=====
PennDOT BQAD Publications e-Notification
Bureau of Design
Bridge Quality Assurance Division
=====

Publication No. 218M & 219M
Standard: All Current
RE: Linked PDF files
No. 14
Date: 1-29-07 w/ 11-28-07, 4-24-13 & 12-30-13 updates

PennDOT e-Notification No. 30

Interim Revision to Bridge Standard Drawing(s)	BD-601M, "Concrete Deck Slab", Sheet 4, dated 9/20/2010. Sidewalk Cross slope and reinforcement revisions.
--	--

e-Notification No. 49 – BD-601M, Sheet 8:

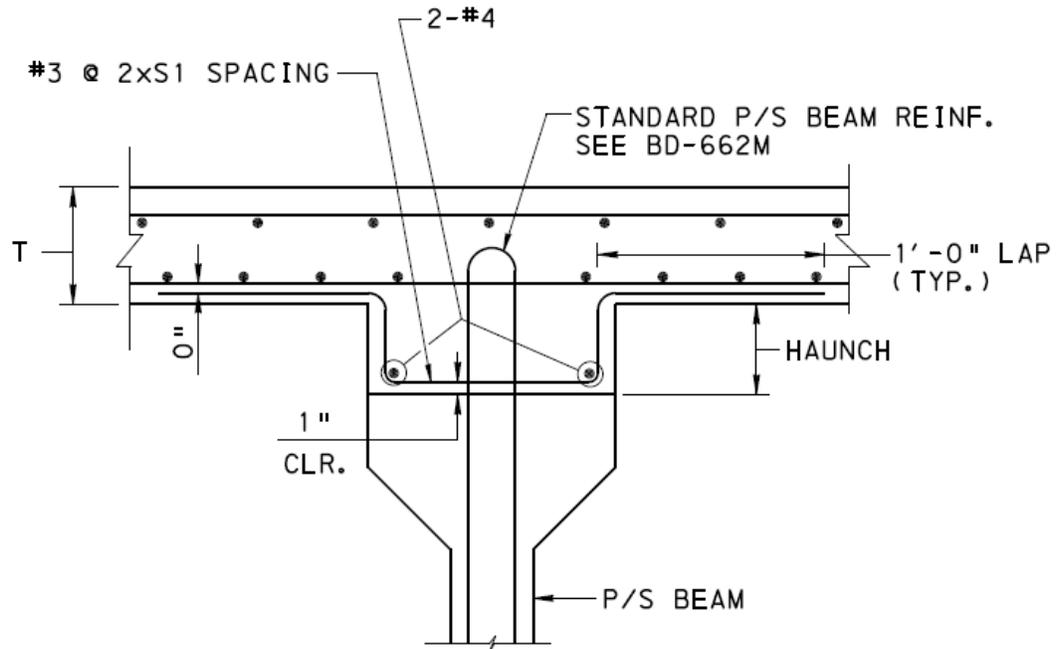
Sht. 8, HAUNCH REINFORCEMENT DETAILS – P/S CONC. PA I-BEAM & PA BULB-TEE BEAMS: Revise haunch thickness limit from 3” to 5” in note beneath title of this detail. Also, added WITH SIP FORMS FOR INTERIOR BAYS to end of this same note.

5"

WITH SIP FORMS FOR
INTERIOR BAYS

REMOVABLE HAUNCH FORMWORK DETAIL
INTERIOR STEEL BEAM/GIRDER

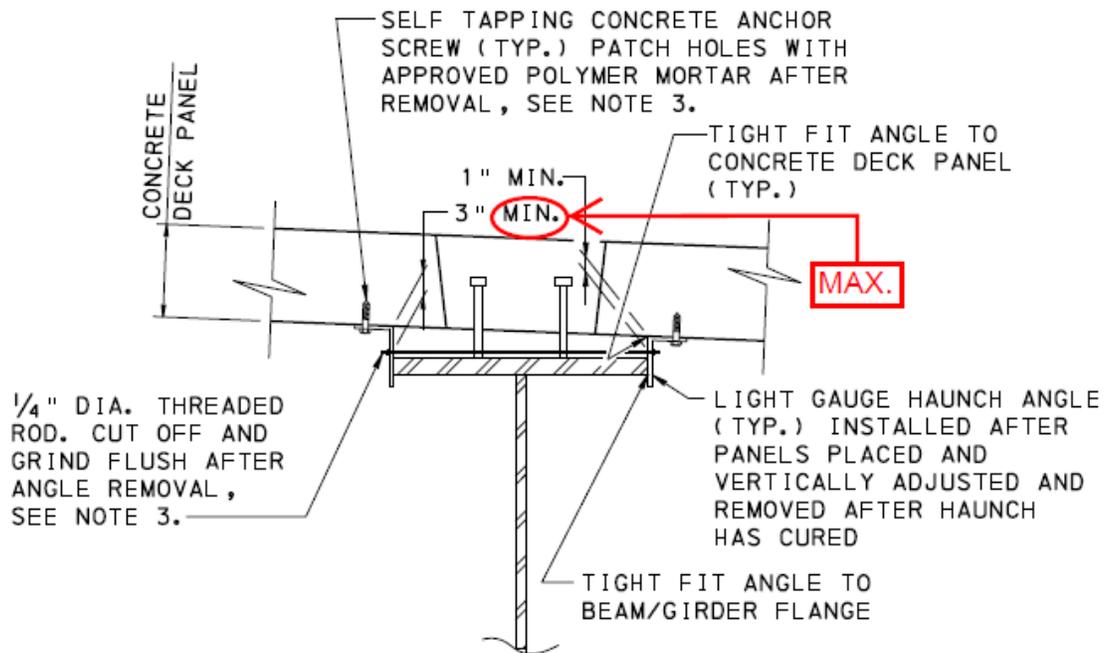
Sheet 4 – REMOVABLE HAUNCH FORMWORK DETAIL – INTERIOR STEEL BEAM/GIRDER: Maximum haunch thickness corrected to read 3" MAX. instead of 3" MIN.
